REVISED RESPONSE TO REQUEST FOR ADDITIONAL INFORMATION

APR1400 Design Certification

Docket No. 52-046

RAI No.: 481-8546
SRP Section: 16 – Technical Specifications
Application Section: 16.3.4, 16.3.5, 16.3.6, 16.3.7, 16.3.9
Date of RAI Issue: 05/12/2016

Figure 4.3-1 (page 1 of 1)
Discrete Two Region Spent Fuel Storage Rack Layout

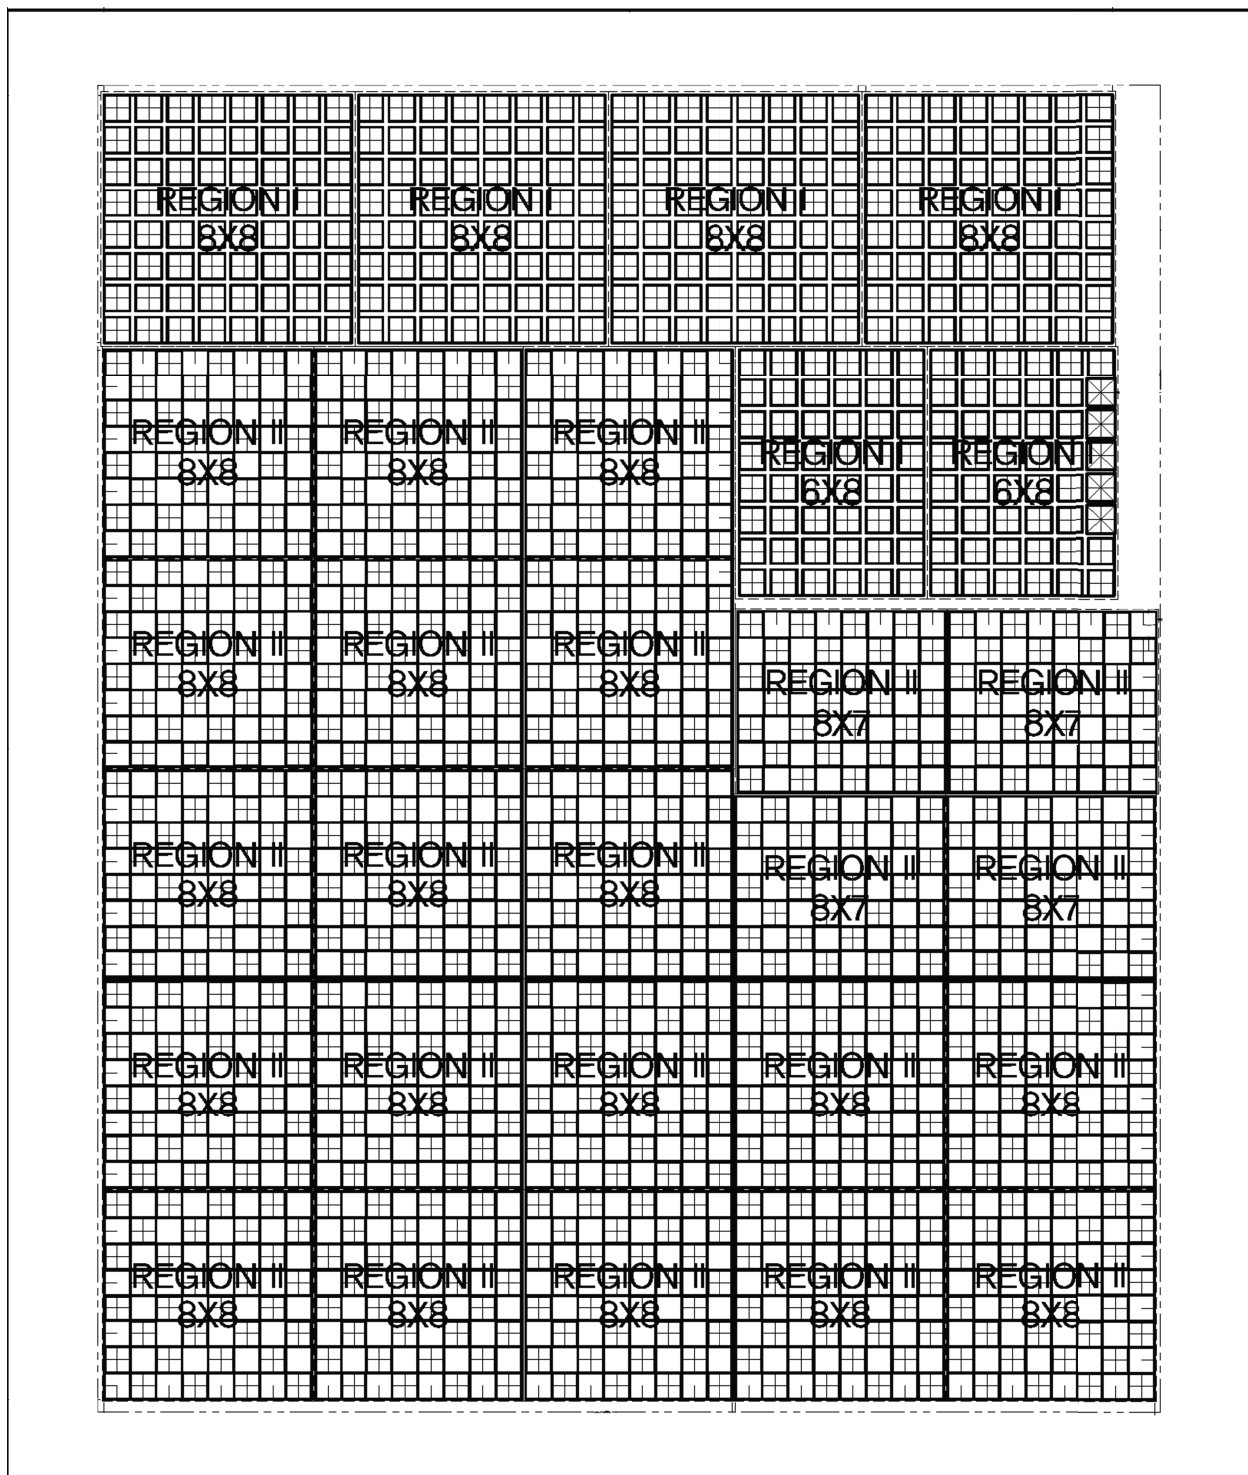
- A. Revise the proposed change to TS 4.3.1.1.b to reflect the design criteria for spent fuel storage racks described in DCD Subsection 9.1.1.
- B. Add a Figure to Section 4.3 showing the physical lay-out of the spent fuel pool that clearly identifies the locations of Region I and Region II storage racks within the spent fuel pool.
- C. Revise the Background section of the Bases for TS 3.7.16 to include a discussion of the minimum boron concentration credited in the criticality analysis that is described in DCD Subsection 9.1.1.
- D. Add TeR APR1400-Z-A-NR-14001-P, Rev.0 to the References section of the Bases for TS 3.7.16.

2. Editorial clarification in the response to RAI 120-7977, Subquestion 3 will be revised.
3. TS Bases B 3.7.5 LCO section will be revised to include suggested changes for clarify.
- 4-A.TS 4.3.1.1.b, e and f will be revised as indicated in the attached markup.
- 4-B.Figure 4.3-1 will be added to identify the locations of Region I and Region II storage racks within the spent fuel pool.
- 4-C.Background section of the Bases for TS 3.7.16 will be revised to include a discussion of the minimum soluble boron concentration credited in the criticality analysis.

shall be stored only in the Region I of Figure 4.3-1.

This figure will be added to Section 4.3
